Sultana Sweaters Limited

02 & 16 February 2021

Observations

Gable frame section of Shed 1

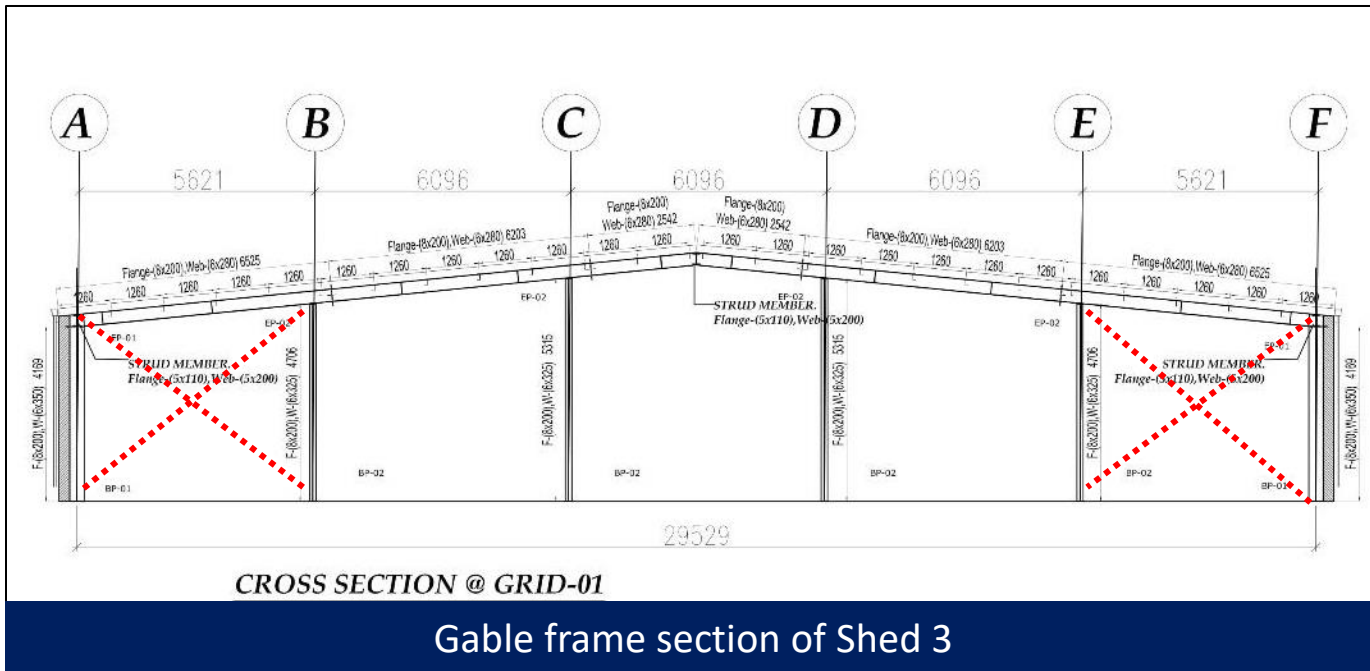
Missing bracing at Several Location

Missing Bracing

| Item No. | Observation | Recommended Action Plan | Recommended Timeline |
|----------|--|---|----------------------|
| 05 | Missing bracing at several locations. (Shed 1,3,4, Substation 1 & 2) | Building engineer is required to re-install all the missing bracing as per the design specifications. | 6-weeks |

Section details of grid-A

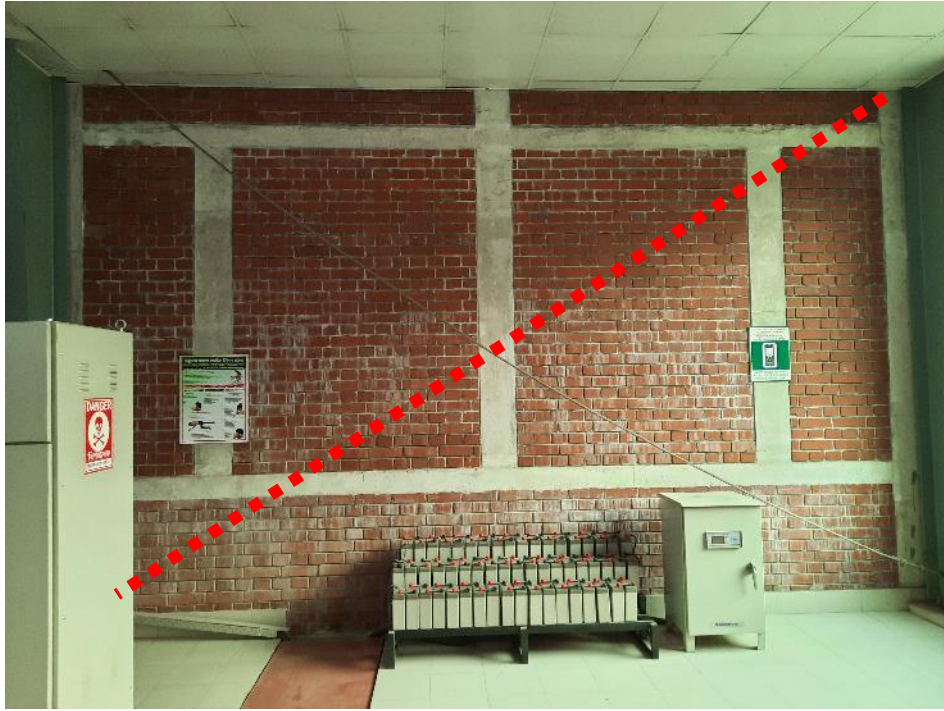
Missing Bracing

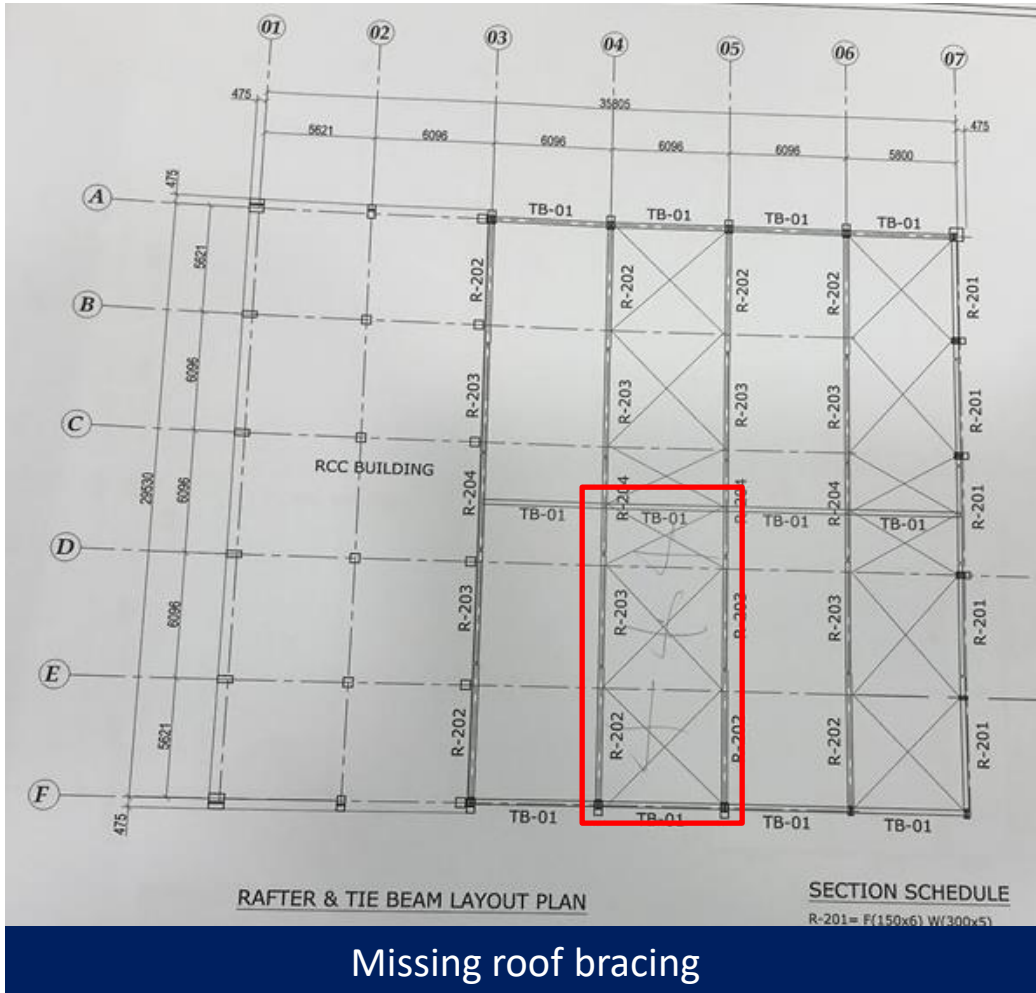
Missing wall bracing

Missing roof bracing

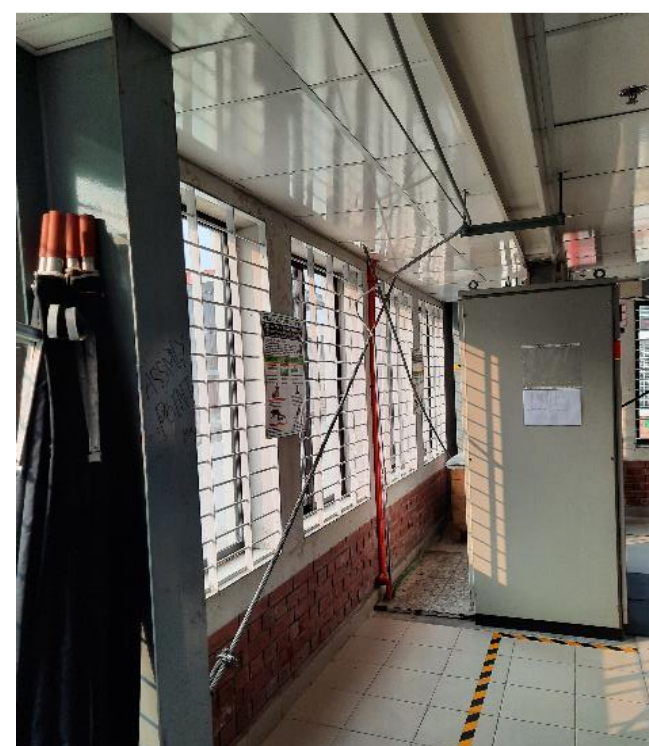
Loose cable bracing

| Item No. | Observation | Recommended Action Plan | Recommended Timeline |
|----------|--|---|----------------------|
| 04 | Loose cable bracing. (All Sheds) | Building engineers required to tighten all the loose bracings. | 6-weeks |

Typical long section of the bracing in long direction

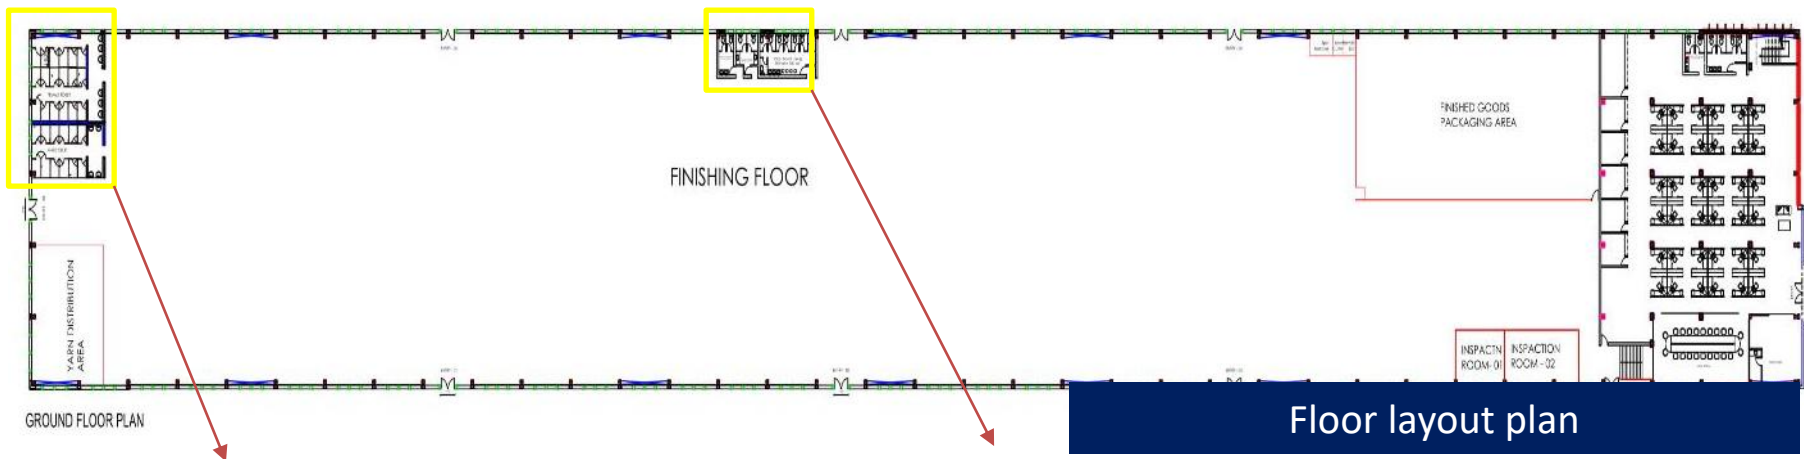
Bracing interrupted in some locations

Bracings are interrupted in toilet zone (Shed 4,5,6,7)

Bracings are offset from the node point- Shed 5

| Item No. | Observation | Recommended Action Plan | Recommended Timeline |
|----------|---|---|----------------------|
| 08 | Bracing interrupted in some locations. (Shed 4, 5, 6, 7) | Building engineer is required to check the existing bracing system and the load path of the bracings. | 6-weeks |

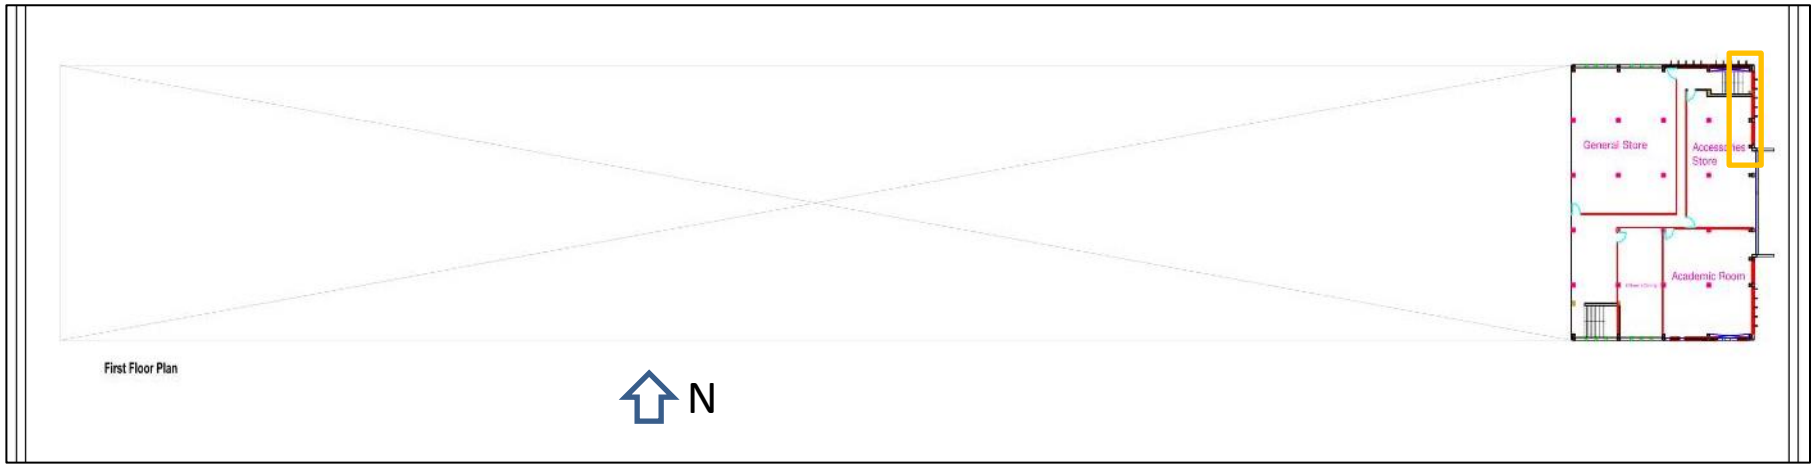
Water tank supported on the toilet zone partition wall

Water tanks are supported on the 125 mm and 250 mm brick walls. Building engineer is required to check the load carrying capacity of the walls.

Corrosion on toilet zone steel column

Corrosion was observed on the toilet zone steel columns of shed 4 & 5. Building engineer is required to remove rust and apply anti corrosive paints.

First floor layout plan of Shed 5

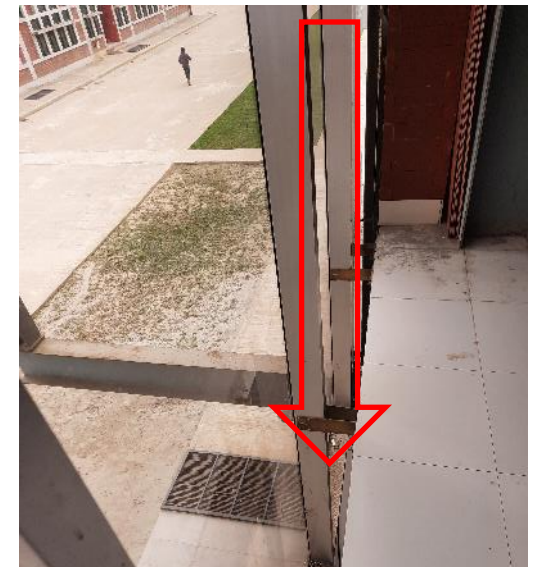
Falling hazard at East zone-Grid 39

No edge protection provided on this gable grid. Falling hazard may occurred anytime. Building engineer is required to provide edge protection on this area.

| Item No. | Observation | Recommended Action Plan | Recommended Timeline |
|----------|---|--|----------------------|
| 14 | Falling hazard at East zone-Grid 39. (Shed-5) | Building engineer is required to provide edge protection on this area. | 6-weeks |

Column layout plan and column schedule

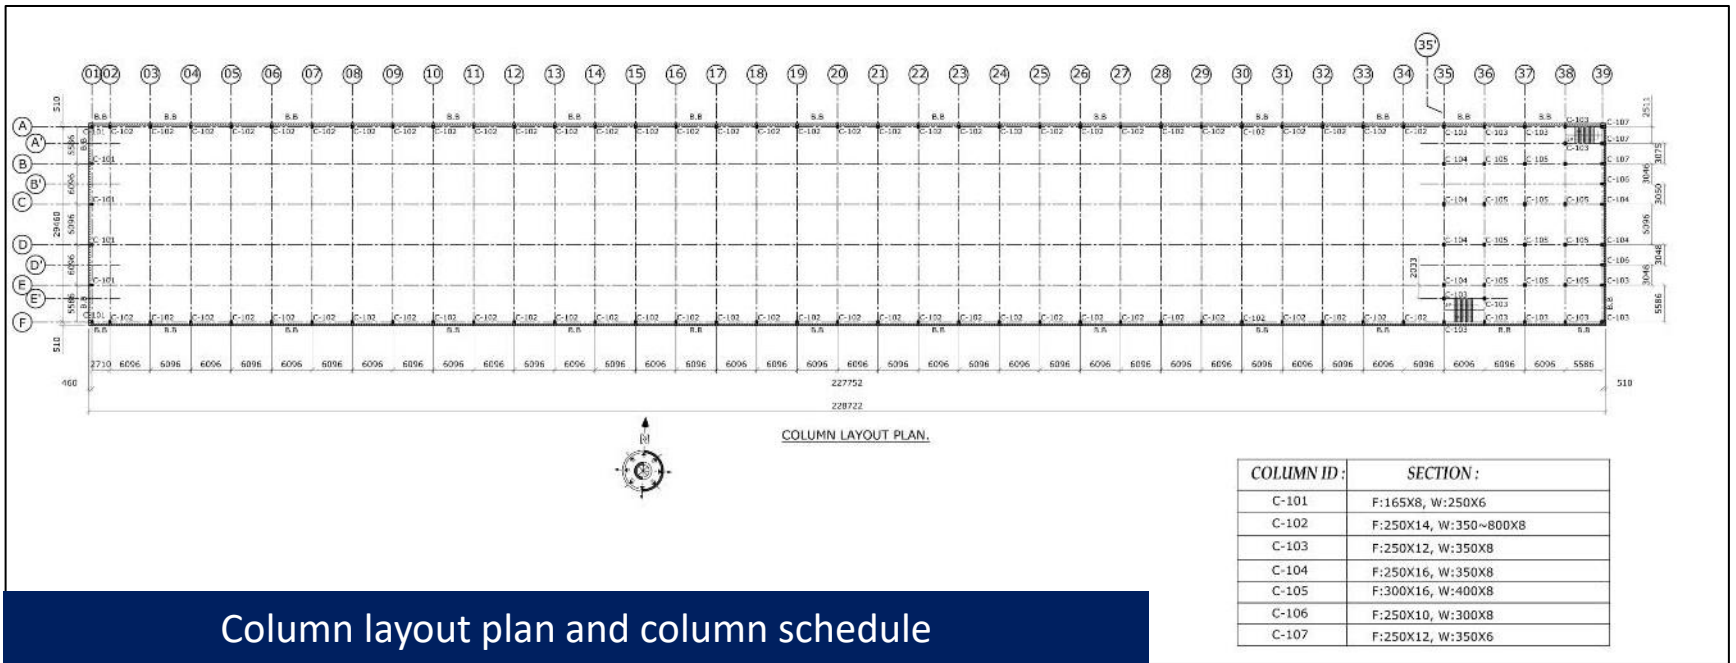
Inconsistency in as-built drawing

C-105 column was measured F 300X16, W 345X8 instead of F 300X16, W 400X8. Building engineer is required check the column capacity considering reduced size also update the as-built drawings.

| Item No. | Observation | Recommended Action Plan | Recommended Timeline |
|----------|---|--|----------------------|
| 15 | Inconsistency in as-built drawing. (Shed 5 & Boiler Room 1) | Building Engineer to survey the structure and prepare accurate as-built structural drawings. | 6-weeks |

Column schedule

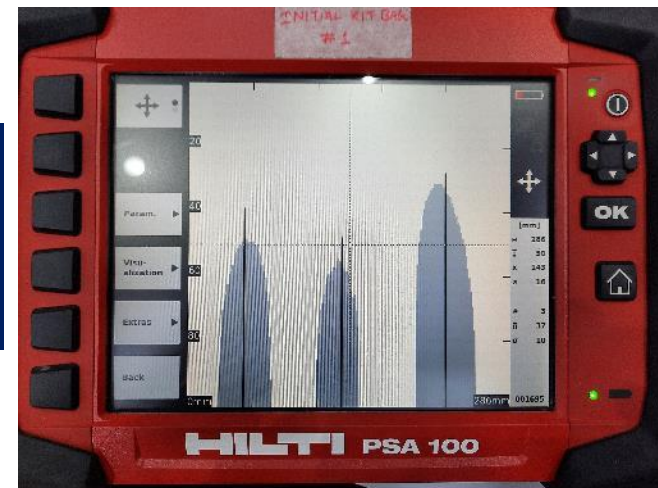
Total number of rebar counted 10-16 mm diameter by ferro scanner instead of 12-16 mm diameter. Building engineer is required to check the column adequacy and revise the as-built drawings.

Live Load plan of the roof

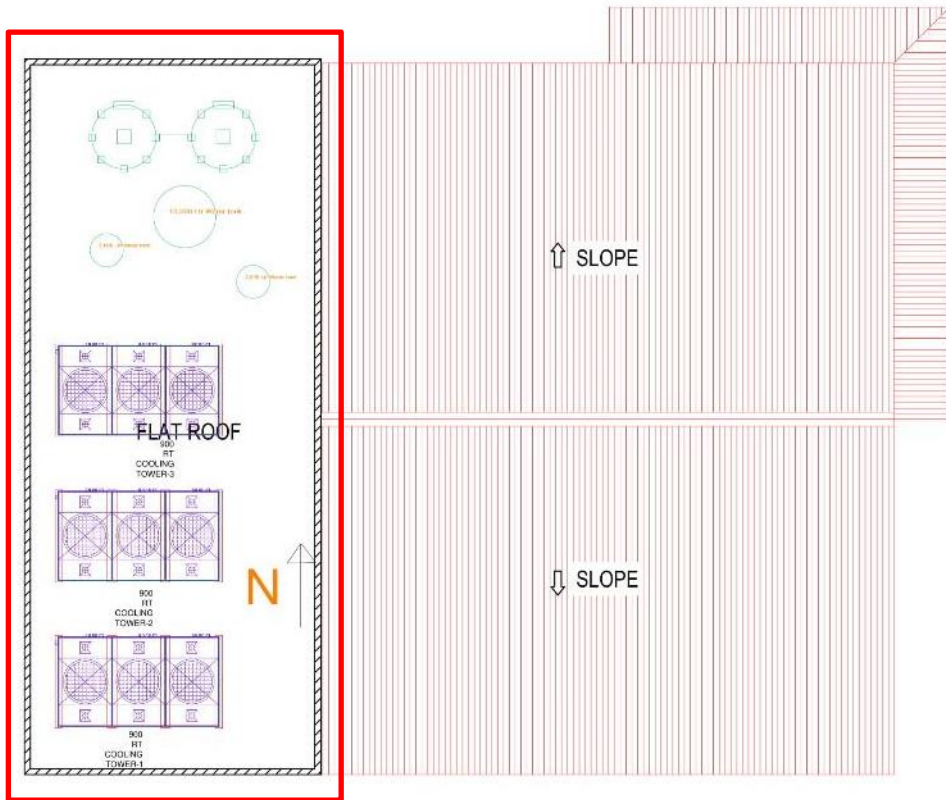
Heavy loading on roof slab

Heavy loading was observed on the roof of substation roof. Building engineer is required to check the flexure capacity of the slab.

| Item No. | Observation | Recommended Action Plan | Recommended Timeline |
|----------|--|--|----------------------|
| 16 | Heavy loading on roof slab. (Utility & Sub-Station Building 2) | Building Engineer is required to check the flexural capacity of the slab to carry the imposed loading. | 6-weeks |
